Subject: Certification of H-3 Flammable Storage Building at the Safety-Kleen Albuquerque, New Mexico, Branch

CERTIFICATION OF H-3 FLAMMABLE STORAGE BUILDING
ALBUQUERQUE, NEW MEXICO

INSTALLATION CERTIFICATION
H-3 FLAMMABLE STORAGE BUILDING

MARKED BY RCS DURING 4/9/92 SITE VISIT

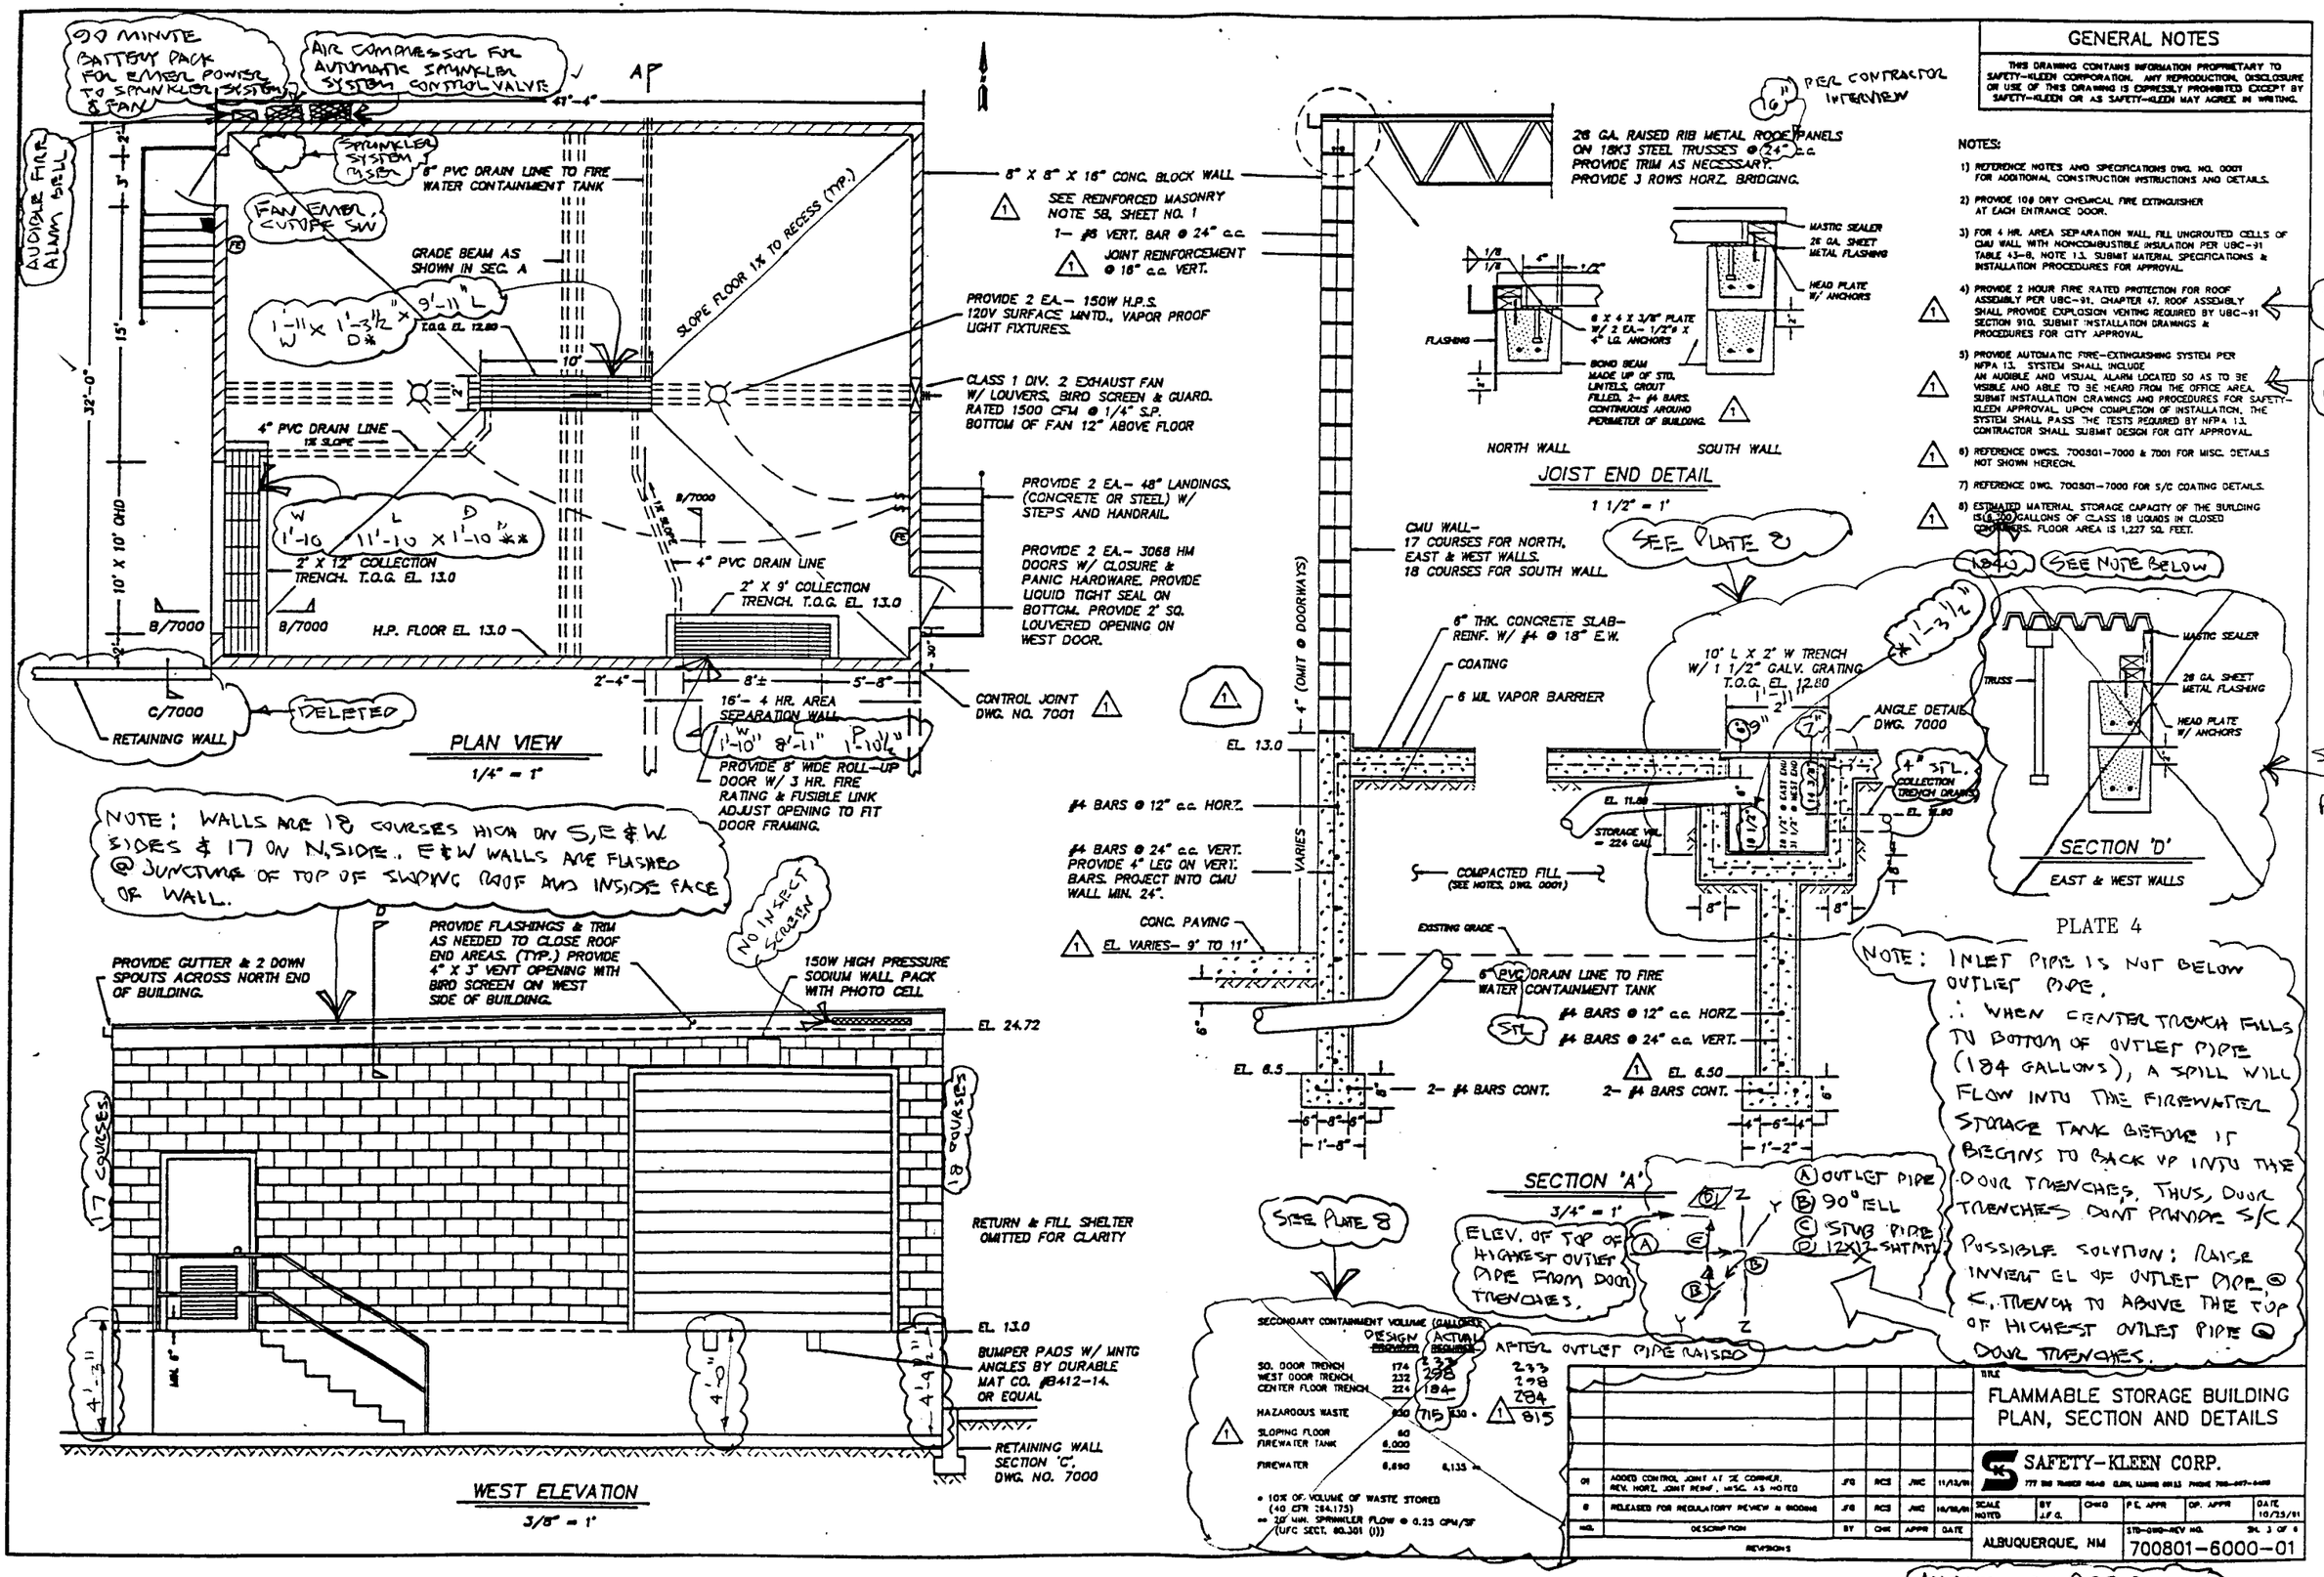
The dimensions of the building and its secondary containment are shown on Safety-Kleen drawing number 700801-6000-01, which is Plate 4 of this report. Inspection revealed that the major as-built dimensions of the building and its secondary containment closely follow those shown on the design drawings, except as shown on Plates 4 and 8.

Inspection by TERA on April 9, 1992 revealed that the outlet pipe from the center trench was not installed above the door trench pipes as designed (See Plate 4 and Photo B on Plate 18). The contractor corrected this deficiency during April 10-13, 1992 as shown on Plates 8 and 19. A 90-degree elbow was installed to elevate the mouth of the center trench outlet pipe above the entrances to the door trench outlet pipes. A square of sheet metal was fastened to the underside of the grate to cover the open mouth of the pipe, which now faces upward. Thus, the firewater collection tank remains isolated from a potential 10% hazardous waste spill within the warehouse. With these modifications, the H-3 Building's secondary containment now appears to satisfy the design requirements of HWMR-6, Pt. V, sec. 264.175 (b)(2).

TRENCH H.W. STORAGE CAPACITY

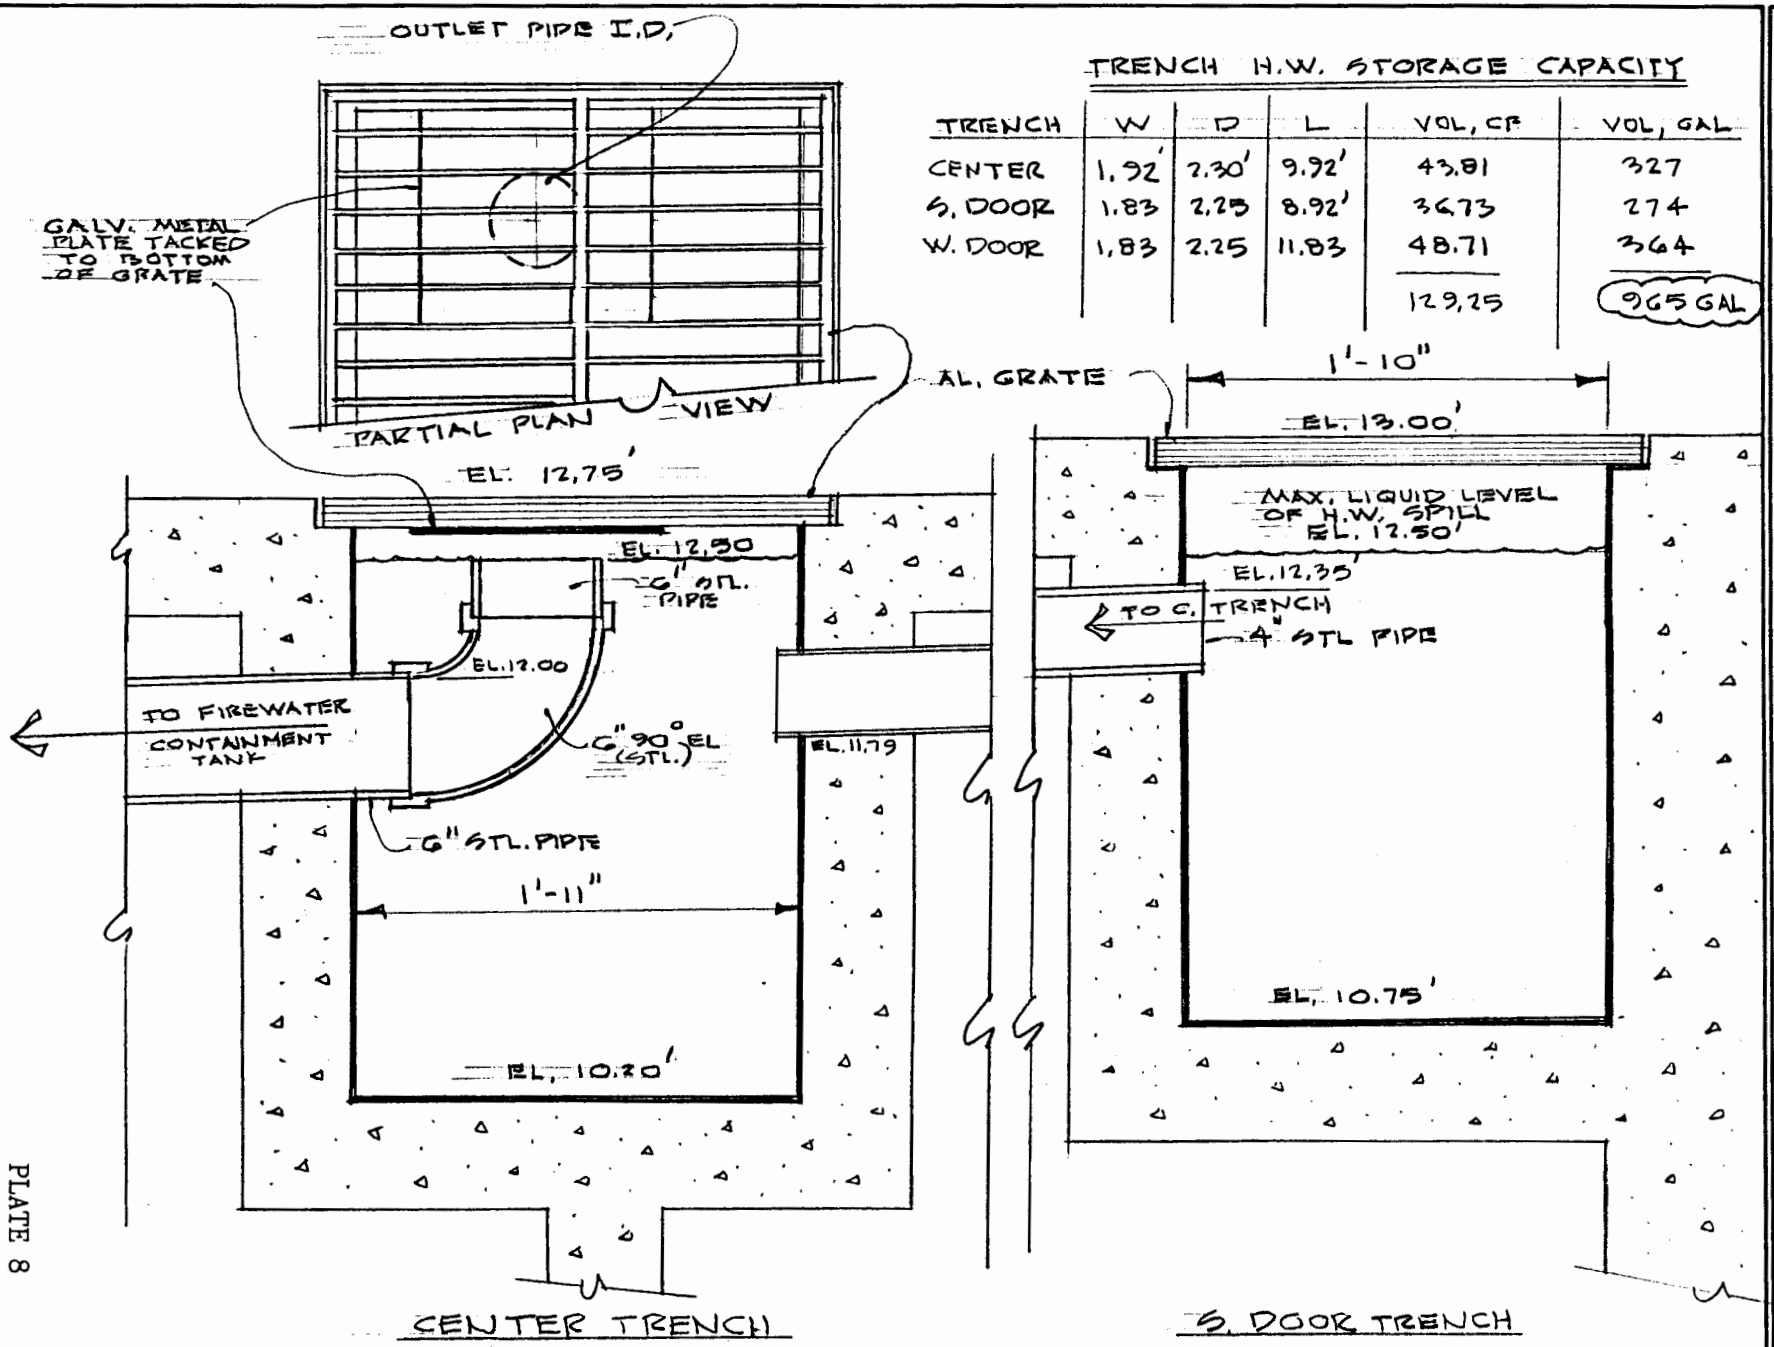
A table showing the as-built volume of the building's secondary containment (i.e two door trenches and the center trench) in on Plate 8. The total volume of the secondary containment is 965 gallons, which is about 88 percent of the 1092-gallon hazardous waste storage capacity for which the

building is currently permitted. Thus, the secondary containment system has substantial reserve capacity: in fact, the center trench alone has sufficient capacity to store more than a 10% spill under the current permit. TERA concludes that the H-3 Building's secondary containment satisfies the capacity requirements of HWMR-6, Pt. V, sec. 264.175 (b)(3).

AS MARKED UP BY RCG DURING 4/9/92 SITE VISIT.

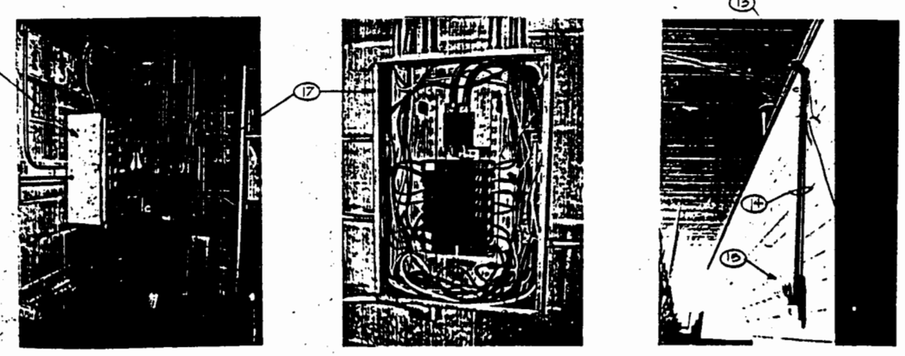
An explosion-proof electrical system has been provided for the H-3 Building (Plates 9 and 10) to prevent accidental ignition of hazardous wastes due to sparks.

H-3 BUILDING
AISLE SPACE

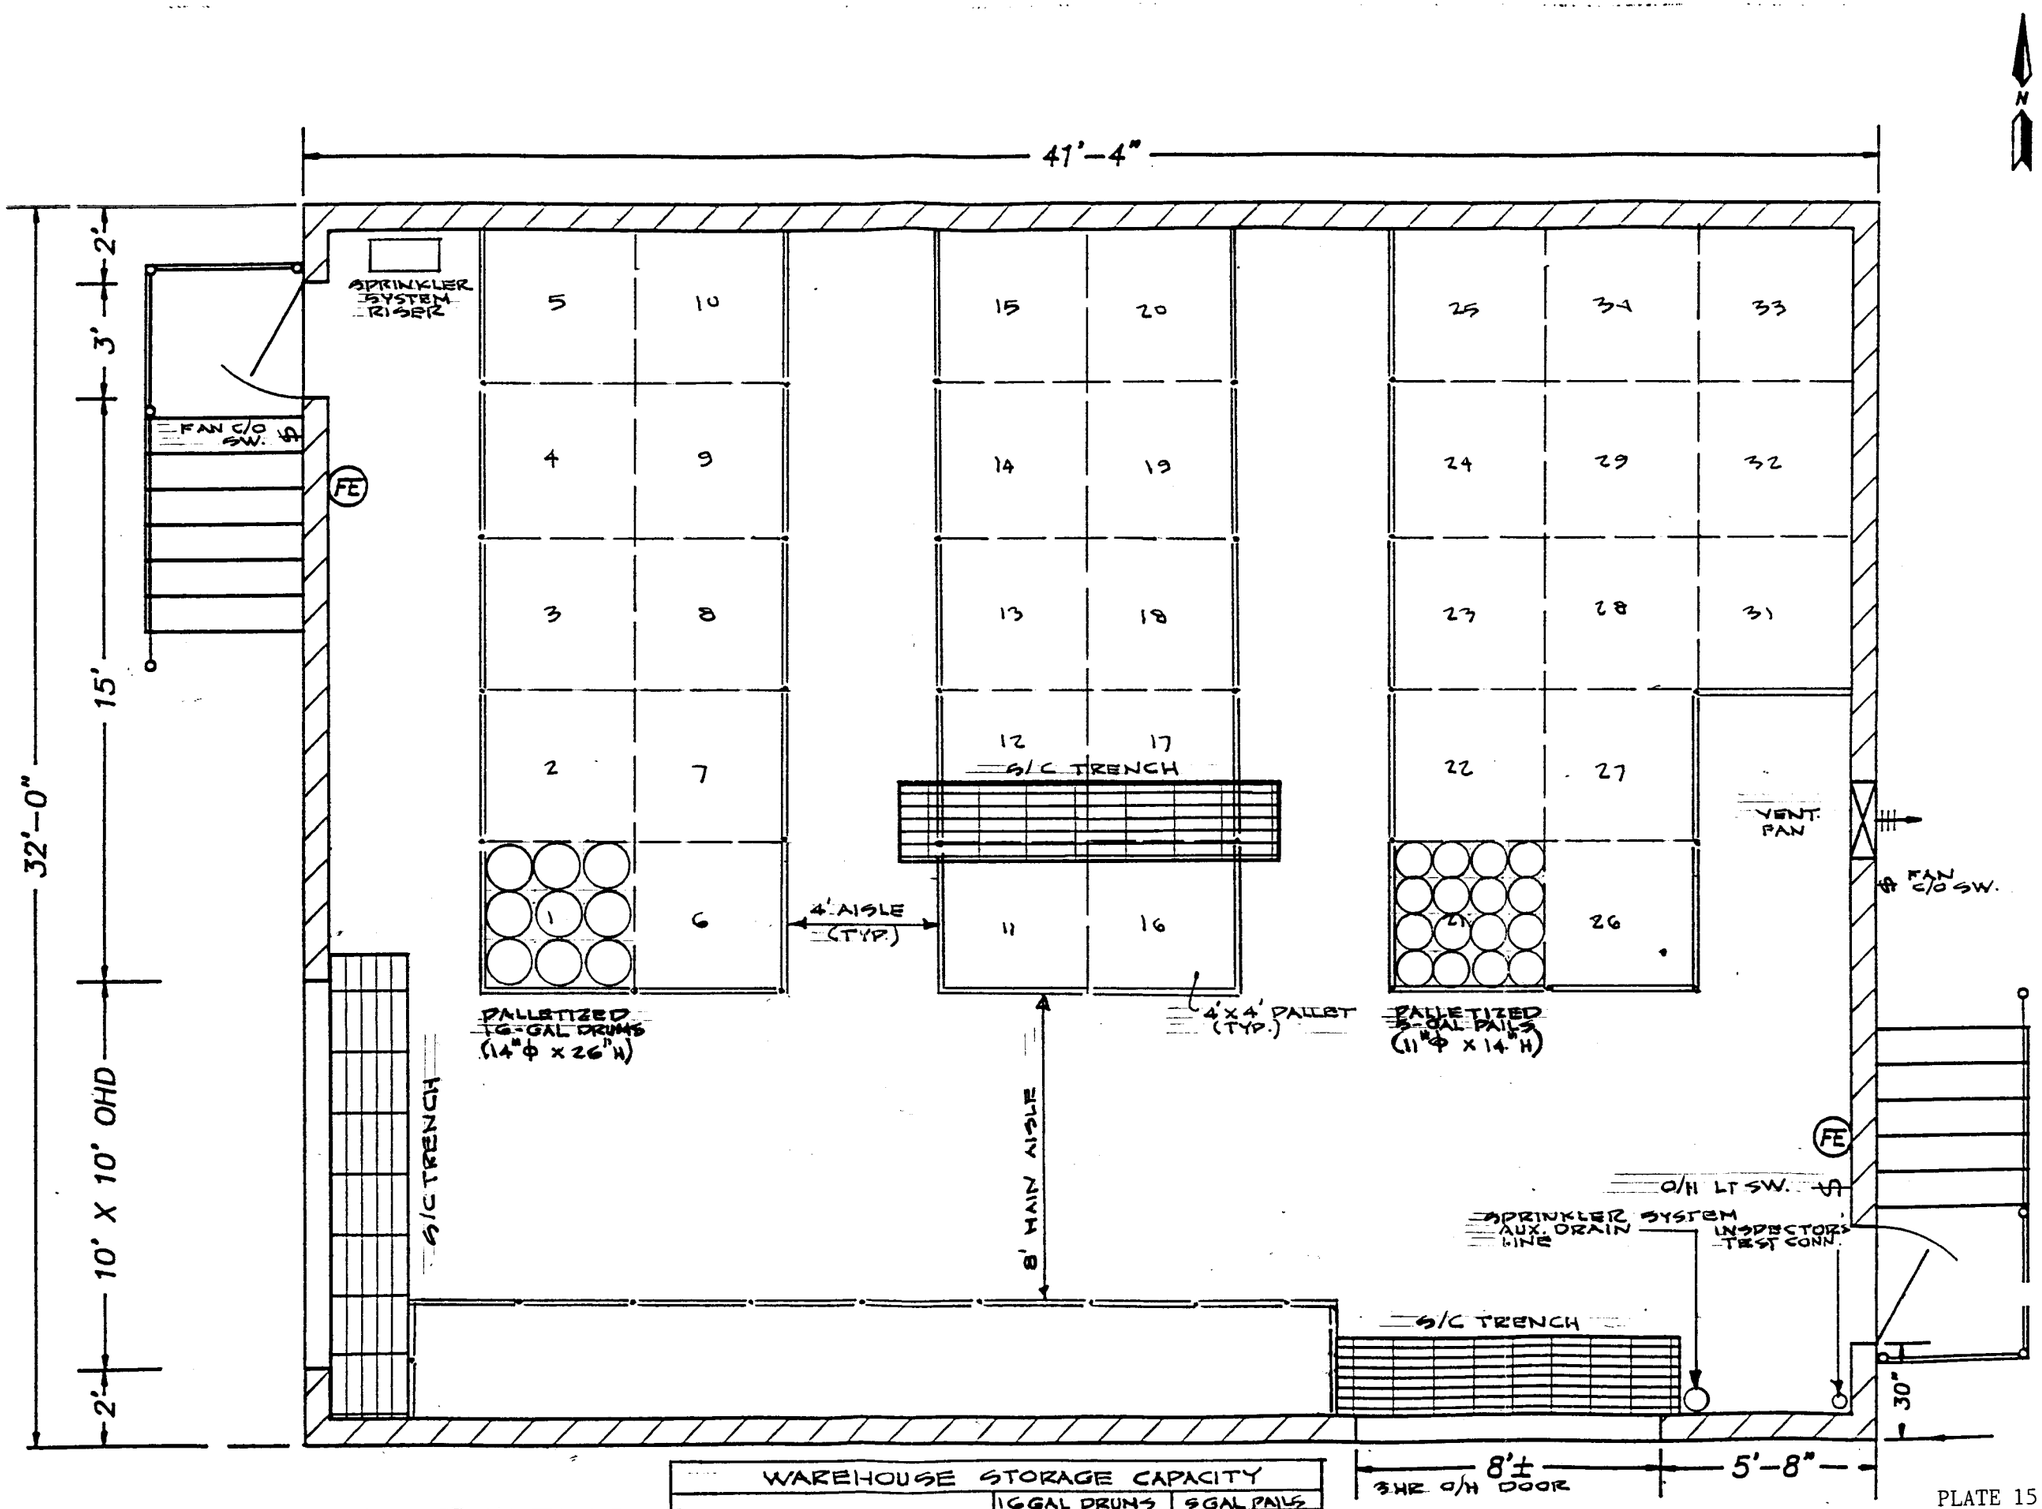
Plate 15 is a floor plan of the H-3 Building showing the aisle space required by the City of Albuquerque fire code (i.e. the Uniform Fire Code). Storage in the warehouse is limited to piles or palletized containers by the 0.25 gpm/sq. ft. capacity of the ceiling sprinkler system (UFC Tables 79.203-C through F). For containers up to 5-gallon capacity, storage height is limited to 6.5 feet (UFC Table 79.203-A). For larger containers, storage height is limited to one container high by the capacity of the

Warehouse aisle space, as shown on Plate 15, satisfies UFC sections 79.203(b), 79.204(b), and 80.304. These code provisions apply to flammable or combustible hazardous liquids storage warehouses. The main aisle is to be eight feet wide; side aisles are four feet wide. Aisles also provide access to exit doors, wall or floor-mounted components of the sprinkler system, the ventilating fan, wall-mounted fire extinguishers, and wall switches, as required by the fire code.

The aisle space provided on Plate 15 allows sufficiently-unobstructed movement of personnel and equipment to any area of the warehouse in the event of a fire, spill, or another emergency. Thus, the layout shown on Plate 15 appears to satisfy HWMR-6 sec. 264.35.
